Re: O3b Limited Response to Commission Questions
IBFS File No. SAT-AMD-20170301-00026 (Call Sign S2935)

O3b Limited (“O3b”) hereby provides the following supplemental information in response to the letter dated June 22, 2017,¹ regarding the above-referenced O3b application.² The text of the questions in the Commission Letter is provided below (with footnotes omitted), followed by O3b’s response for each question.

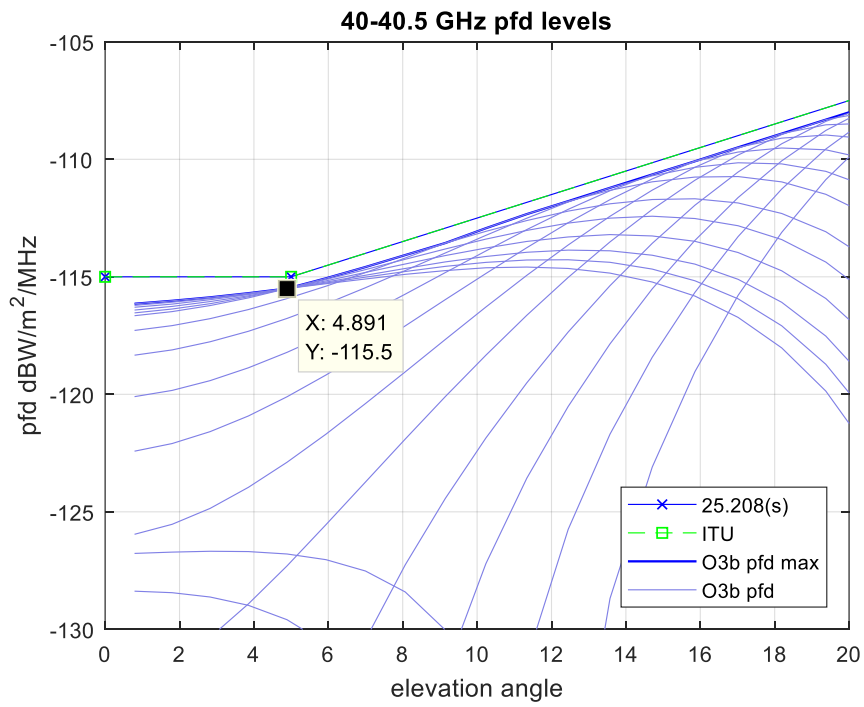
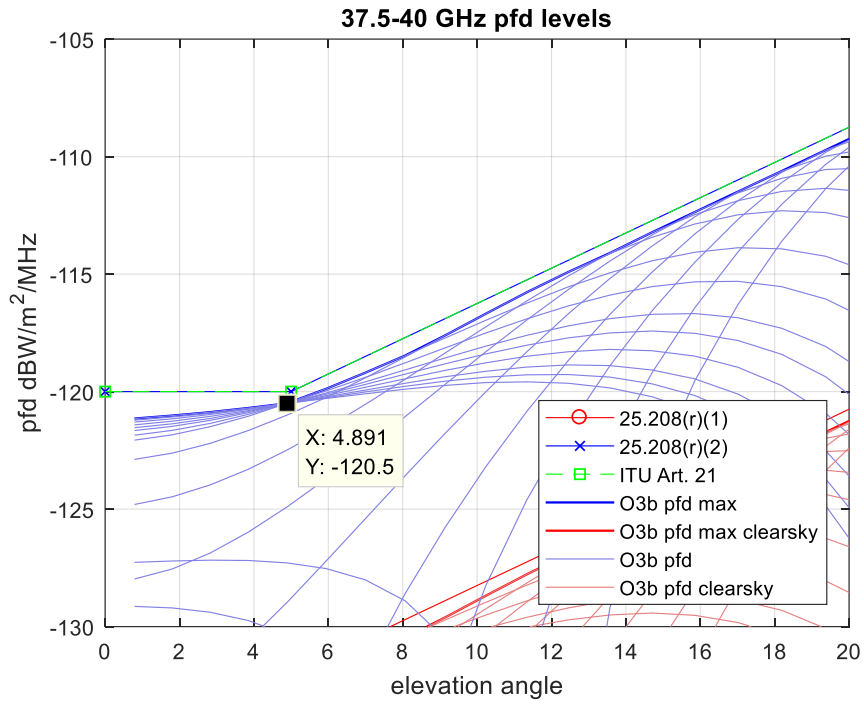
2. The “T[X]_beams.pdf” file attached to the Schedule S form contains an antenna gain contour diagram of a receive beam rather than a transmit beam. Please provide the appropriate transmit antenna gain contour diagram to replace the file labeled “T[X]_beams.pdf.”

The Schedule S submitted with the O3b March Amendment included two attachments designated “TX_beams.pdf,” one associated with the left-hand polarized beam TL1, and the other associated with the right-hand polarized beam TR1. These two beams use only Ka-band spectrum, not V-band spectrum.

The attachments, which were included with the Schedule S submissions for both O3b’s November 2016 Amendment³ and the O3b March Amendment, are incorrectly labeled with titles indicating that they depict receive rather than transmit beam contours. However, the contours presented in the attachments are accurate for the Ka-band transmit beams. Correctly labeled antenna gain contour diagrams for the “TX_beam.pdf” attachments for beams TL1 and TR1 are provided in Annex 1, and O3b is separately submitting an erratum to the O3b November Amendment to note the mislabeling of the original attachments and supply the corrected contour maps.

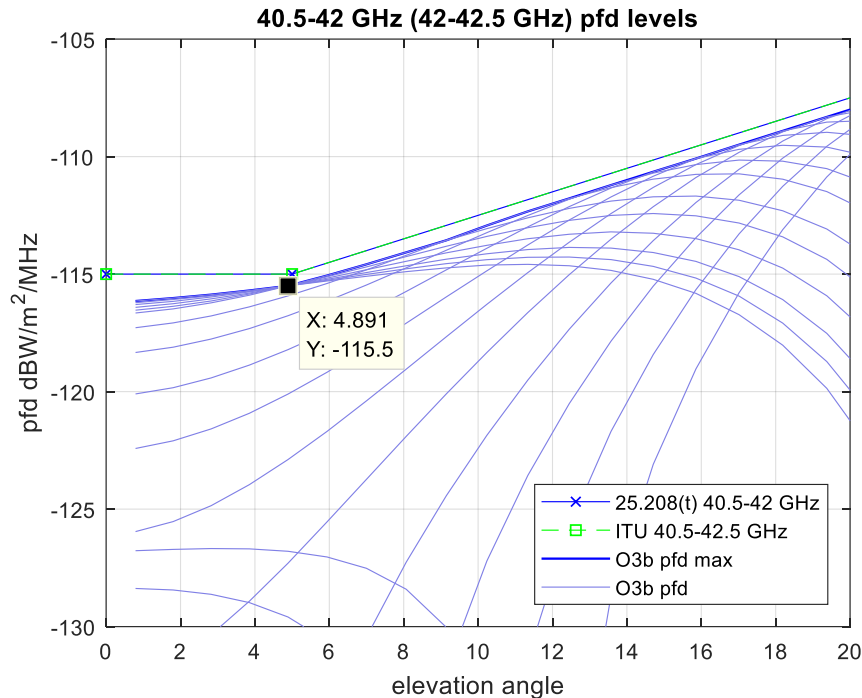
3. In reviewing the PFD analysis provided in Attachment A (pgs. 5-9), and running the calculations O3b presented to justify compliance with the PFD limits of section 25.208, we were unable to replicate the PFD values derived in O3b’s analysis or listed in the Schedule S form. In particular, please explain how the PFD values of $-120.5 \text{ dBW/m}^2/\text{MHz}$ and $-115.5 \text{ dBW/m}^2/\text{MHz}$, mentioned [in] Attachment A (page 8), were derived.

The PFD values of $-120.5 \text{ dBW/m}^2/\text{MHz}$ and $-115.5 \text{ dBW/m}^2/\text{MHz}$ are extracted from the graphs in Figure A.8-1 of Attachment A at approximately the 5° elevation angle. If we adjust the axis limits to zoom in on the $0-5^\circ$ elevation angles, it becomes more clear how these values were determined. The following graphs illustrate the PFD analysis done in Attachment A but focused on $0-5^\circ$ elevation angles and highlighting the nearest data point having the highest PFD in this angular range for any possible beam pointing.

The reason the exact angle of 5° of elevation is not shown (4.891° is shown instead) is due to a conversion issue between the antenna pattern program and the PFD plotting software used.
